DOT/FAA/ND-00/1

Heliport/Vertiport Design Deliberations 1997 - 2000

Robert D. Smith, Editor
Federal Aviation Administration
Washington, DC 20591

May 2001

Figure 1.

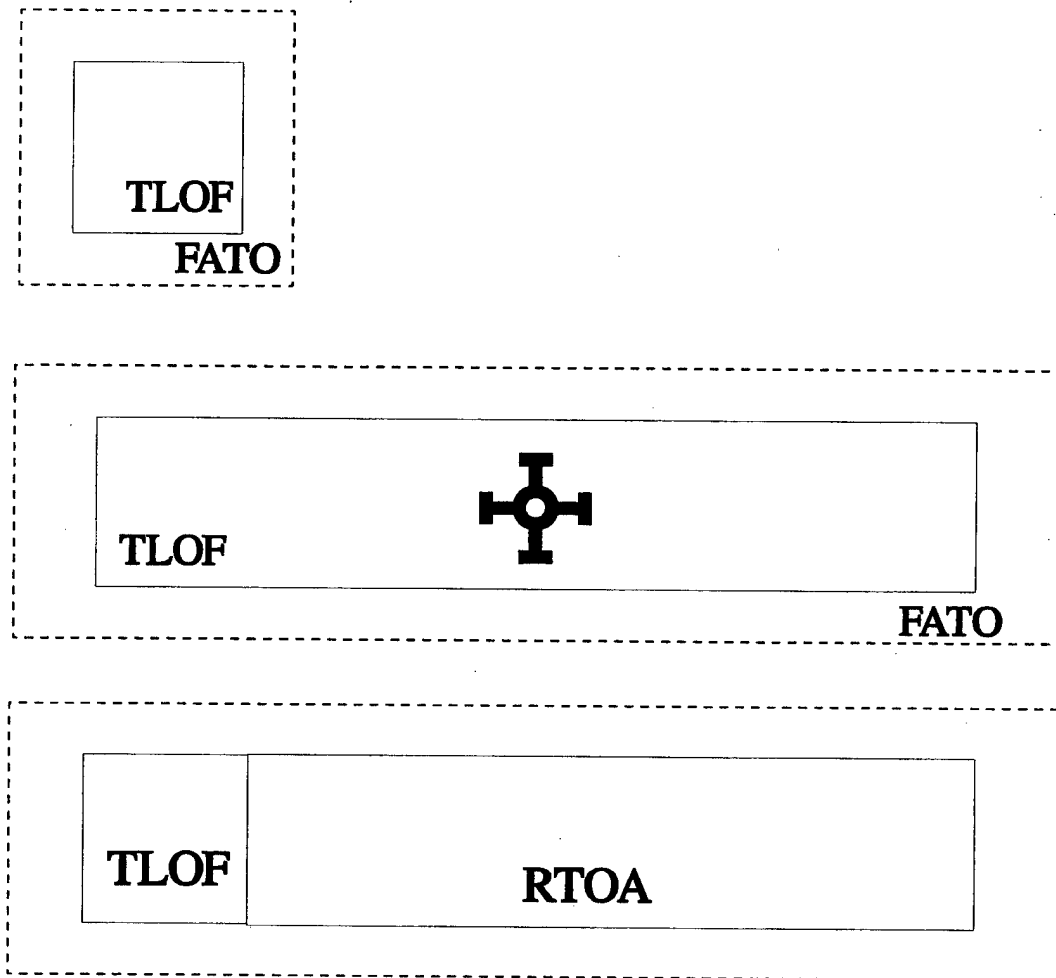
4. Vertiport: Basic Dimensions. Dr. Leverton led the WG through a discussion of what we mean by the terms TLOF and FATO as they are used at a vertiport. At the start of this discussion, he drew several sketches of landing sites under different scenarios. These are shown in figure 1.

Mr. Smith discussed the middle and bottom sketches in figure 1 and the WG's decision to accept NASA's recommendation to place the vertiport marking symbol in the center of the extended TLOF (rollway). This works well in the middle sketch in figure 1. It presents problems in the bottom sketch of figure 1. The WG discussed the possibility of viewing the TLOF/rollway differently for approaches and departures. Several members raised issues concerning the one-way nature of the bottom sketch in figure 1. The WG recognized that a horizontal flip of this sketch would be appropriate for departures in the opposite direction. While this raises marking issues, this topic was not addressed in any detail during the meeting. As the WG discussion continued, the sketches evolved in ways that are difficult to document completely for the purpose of meeting minutes. This evolution led to the set of sketches shown in figure 2.

Figure 3

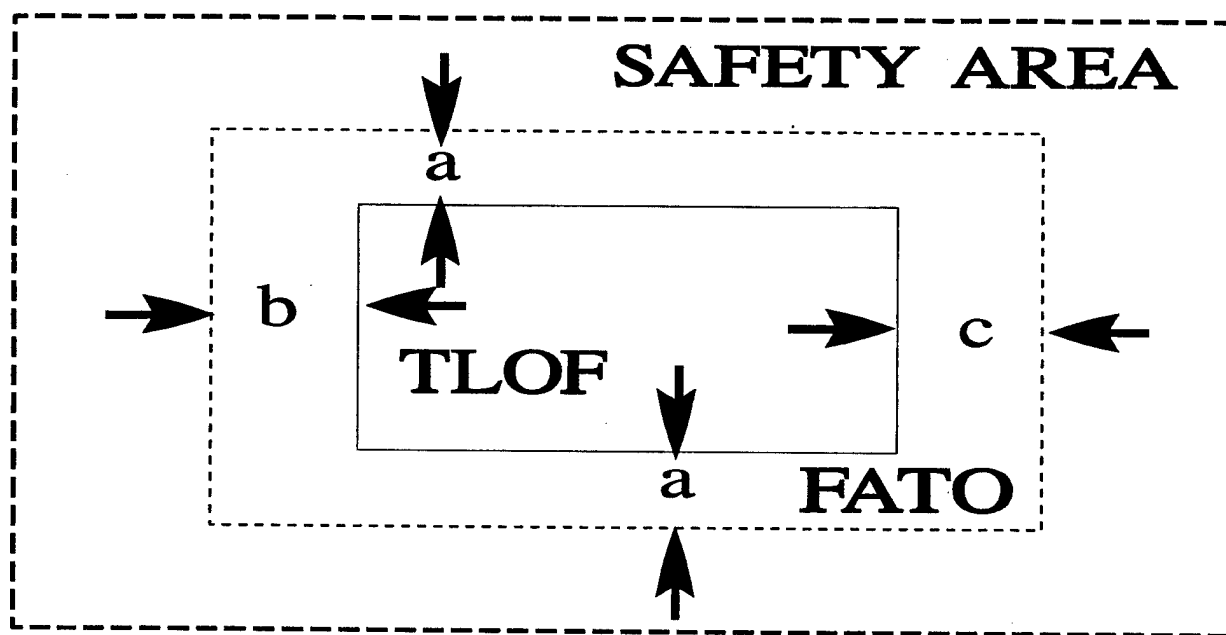
8. Safety Zones/Clearances for FATO. Dr. Leverton led the WG through a discussion of safety areas around a runway. He drew the figure shown below (and labeled figure 3) and asked the WG to comment on the purpose of the protection areas represented by the dimensions a, b, and c.

One WG member suggested that the dimension "a" was intended to account for an off-center landing. Another WG member suggested that it was intended to provide obstacle clearance. Several members commented that they did not know the purpose of the protection area designated by dimension "a".

Figure 4-1. Typical vertiport marking and lighting

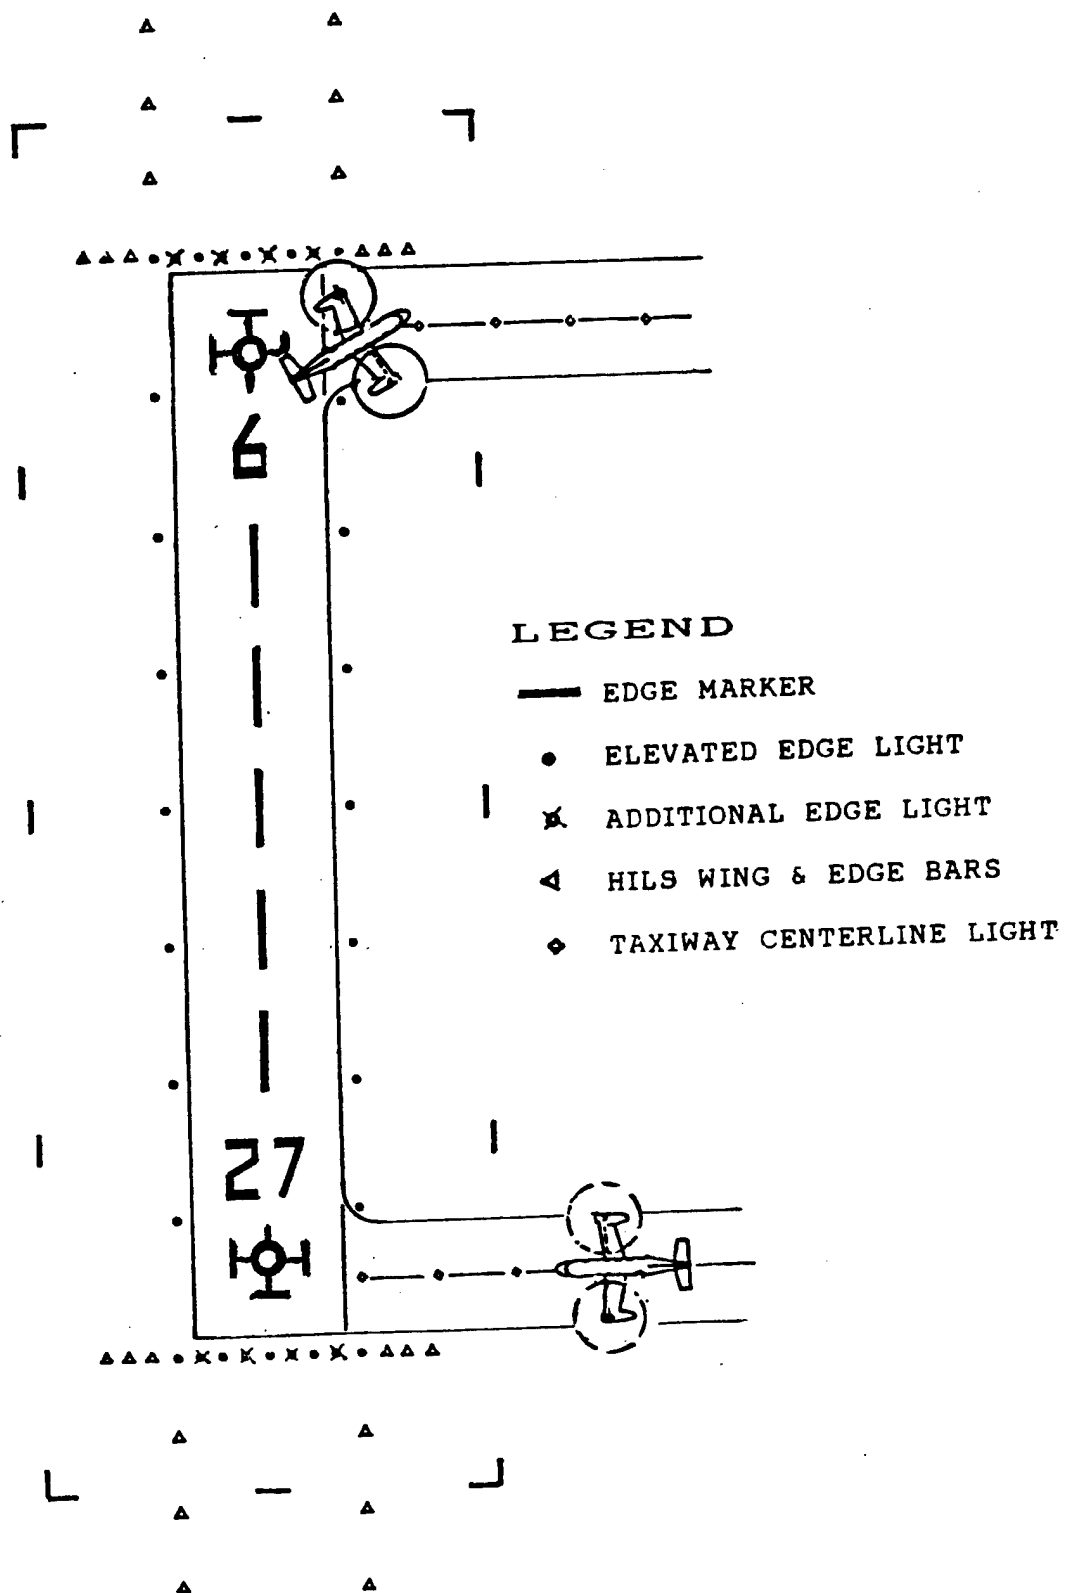
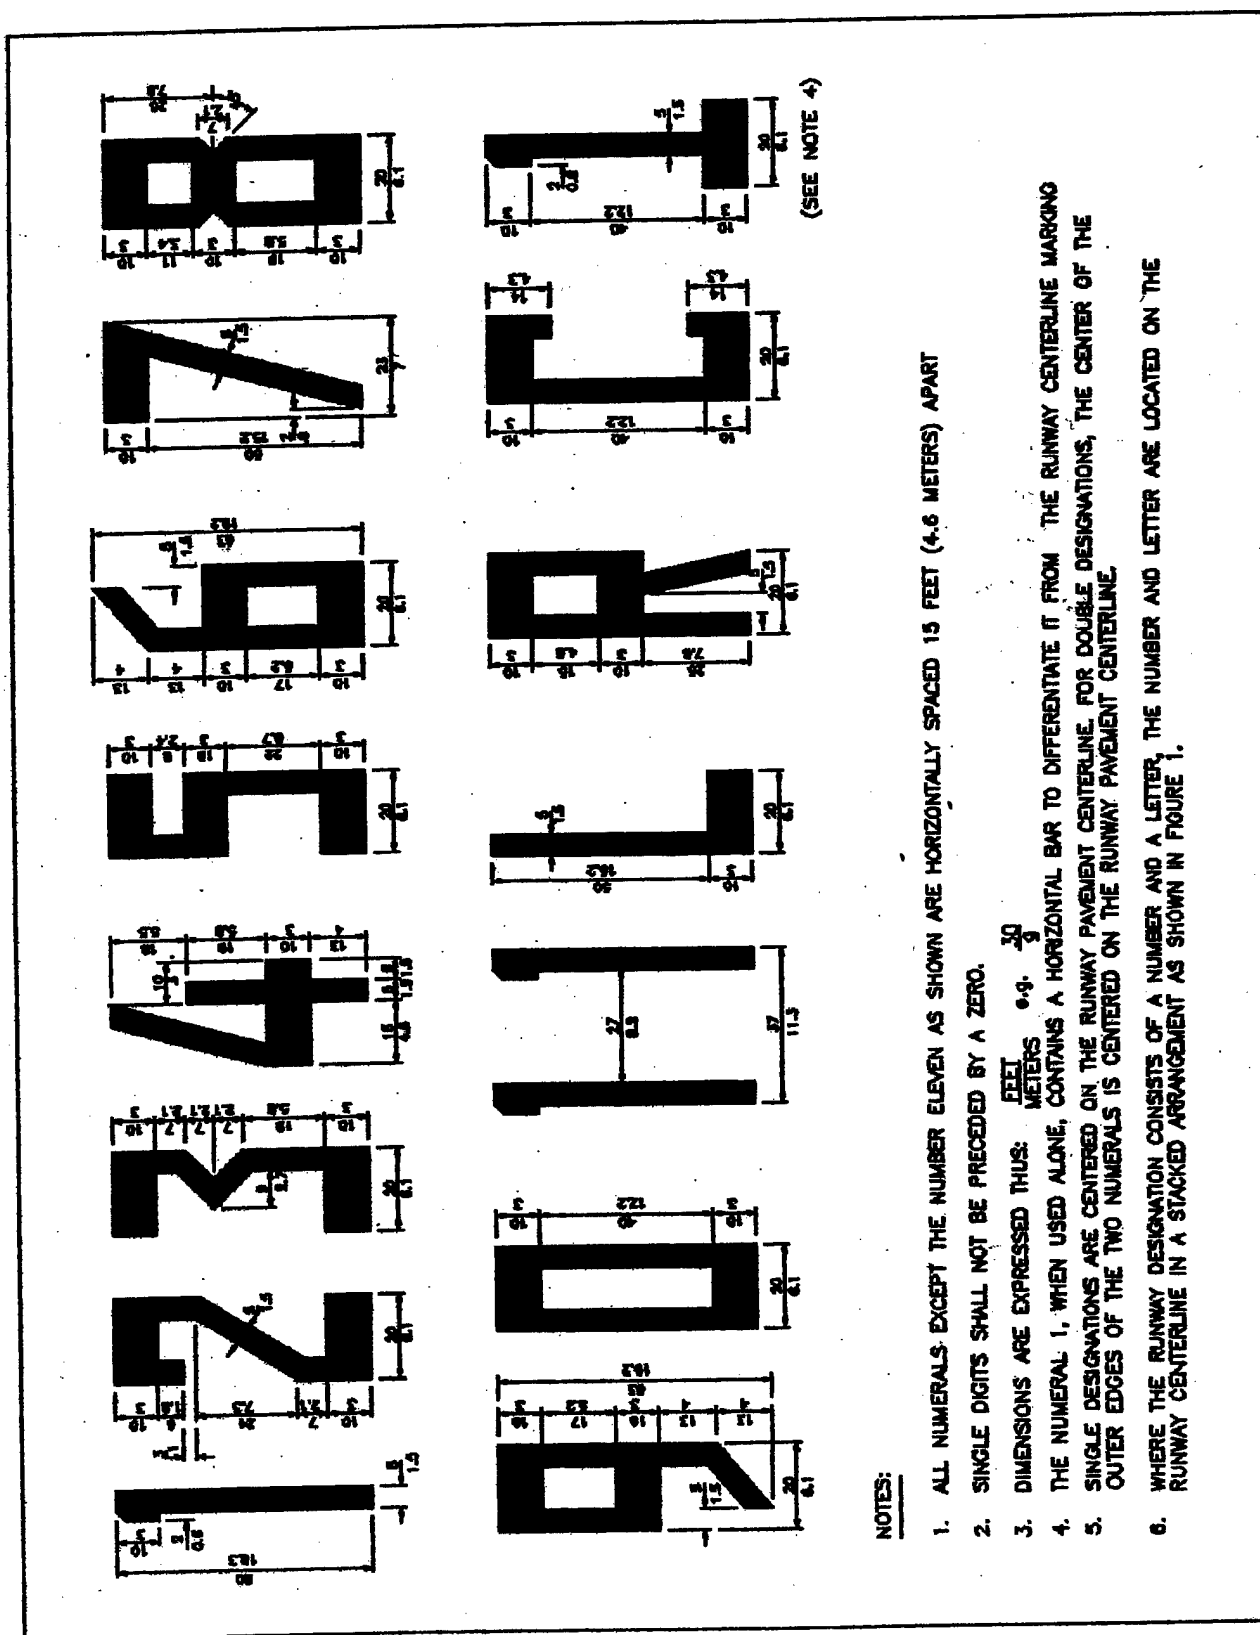
AC150/5390-3, Vertiport Design, shows several illustrations of vertiport TLOF azimuth markings. Figure 4-1, Typical Vertiport Marking and Lighting, is a notable example (shown later in this white paper). However, the advisory circular (AC), says little about the dimensions and the exact placement of these azimuth markings. The following is an excerpt from paragraph 41b(1):

AC150/5340-1G, Standards for Airport Markings, does specify the size and proportion of the azimuth marking in paragraph 6, Runway Designation Marking, subparagraph 6d(2) and figure 4 (shown later in this white paper). This AC recommends that all of the numbers, except the 6 and the 9, be 60 feet tall. A height of 63 feet is recommended for the 6 and the 9. For seven of the ten numbers, a width of 20 feet is recommended. A width of 23 feet is recommended for the 7 and 25 feet for the 4. For the 1, a width of 7 feet is recommended when the number is used in conjunction with another digit. When a 1 is used alone, the AC recommends the addition of a horizontal bar at the bottom to distinguish it from the runway centerline. When this bar is added, the recommended width of the number 1 is 20 feet. Thus, runway designation numerals are roughly 60 feet high and 20 feet wide.

If the simulation pilots found the 28 foot vertiport marking symbol to be inadequate, one can imagine what they would have said about a 14 foot vertiport azimuth marking. However, in this simulation effort, NASA used TLOF azimuth markings consistent with the size and proportions recommended in AC150/5340-1G (60 feet tall). The question now at hand: "Is the guidance developed for 3 degree runway approaches also optimal for approaches to vertiports or is some alteration appropriate?"

Figure 1. Comparison of the Current 1 : 8 Approach/Departure Surface and the Two - Slope Approach/Departure Surface (Two Approach/Departure Paths)

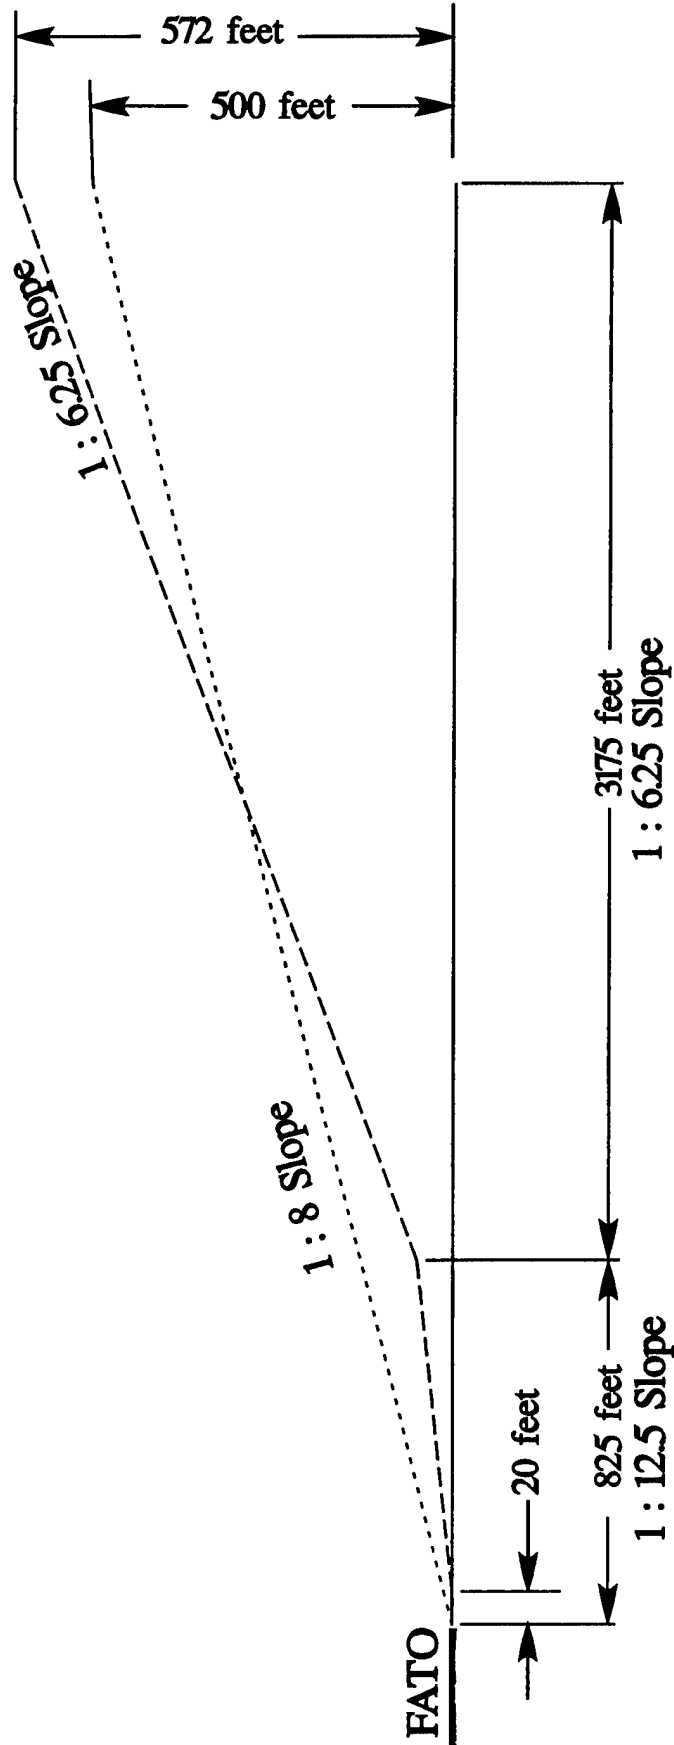
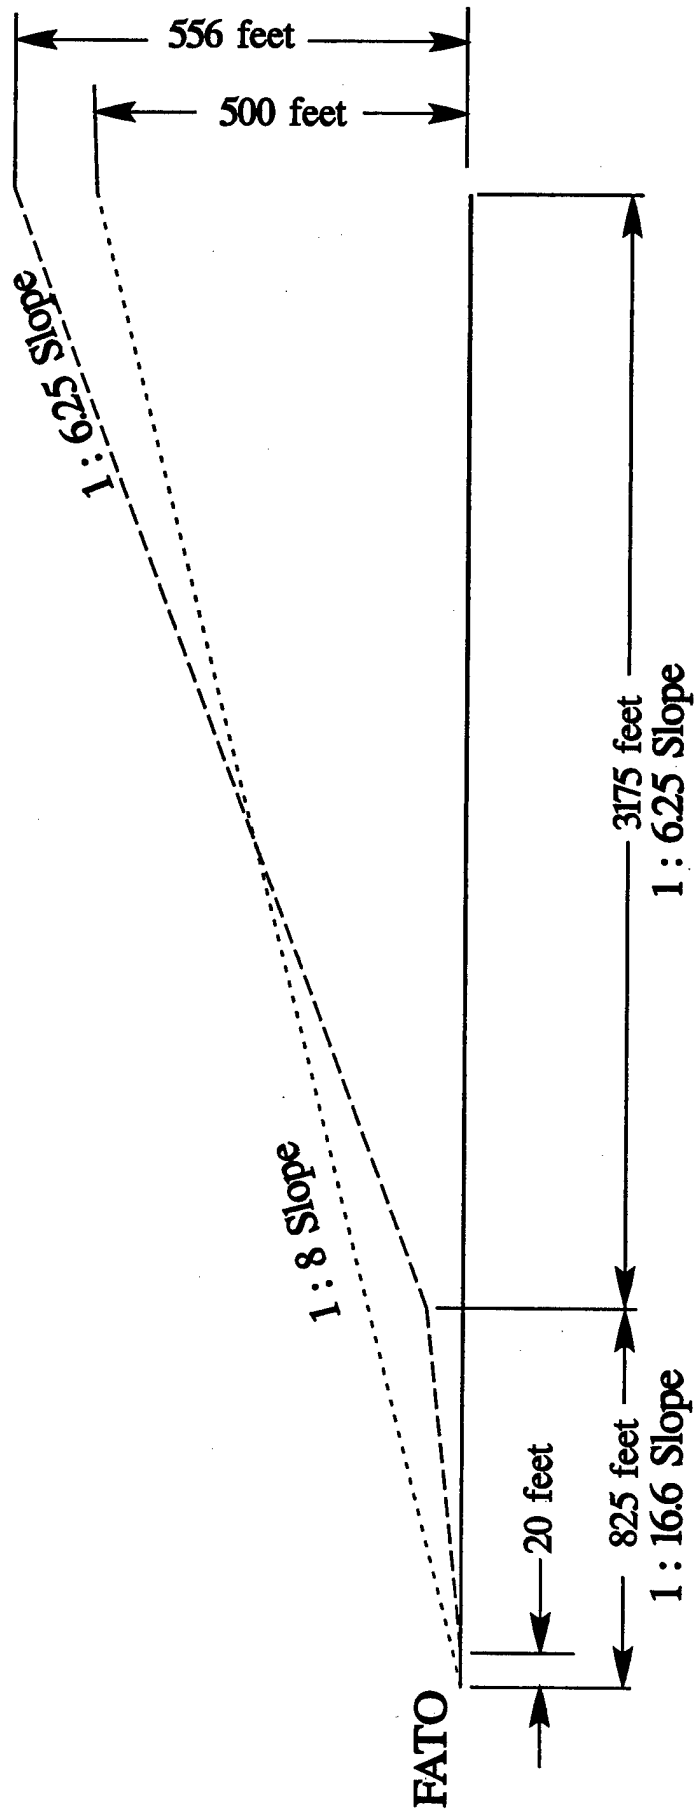
Subsequently, Industry has proposed that AC150/5390-2B be modified to require **only one** approach/departure path at the vast majority of heliports in the nation and that Figure 1 should also apply in such cases. This is an unappealing proposal. Transport Canada's rationale for distinguishing between these two scenarios is sound; it is a simple matter of physics. Helicopter performance deteriorates in the presence of a tailwind. At a heliport with **only one** approach/departure path, the pilot will sometimes be forced to operate with a tail wind. To maintain an adequate safety margin under such a scenario, the additional airspace of Figure 2 is recommended. At the same time, the FAA recognizes that many existing heliports only have one approach/departure path and that a second path is impossible to obtain. How can the FAA

Subsequently, Industry has proposed that AC150/5390-2B be modified to require only one approach/departure path at the vast majority of heliports in the nation and that Figure 1 should also apply in such cases. This is an unappealing proposal. Transport Canada's rationale for distinguishing between these two scenarios is sound; it is a simple matter of physics. Helicopter performance deteriorates in the presence of a tailwind. At a heliport with only one approach/departure path, the pilot will sometimes be forced to operate with a tail wind. To maintain an adequate safety margin under such a scenario, the additional airspace of Figure 2 is recommended. At the same time, the FAA recognizes that many existing heliports only have one approach/departure path and that a second path is impossible to obtain. How can the FAA encourage new facilities to be designed with two approach/departure paths without inadvertently encouraging state aviation authorities to close all current heliports with only one path?

The FAA would strongly prefer to adopt both figures 1 and 2 as Transport Canada has done. Figure 1 would be for heliports with two approach/departure paths (separated by 150 degrees or more). Figure 2 would be for heliports with only approach/departure path. Unfortunately, we have been unable to reach a consensus on this point with Industry. As a compromise, the FAA and Industry have agreed to adopt figure 1. While this is less than ideal, it does provide an additional safety margin in comparison with the current Heliport Design AC recommendations. This additional airspace would also provide operators with additional operational flexibility.
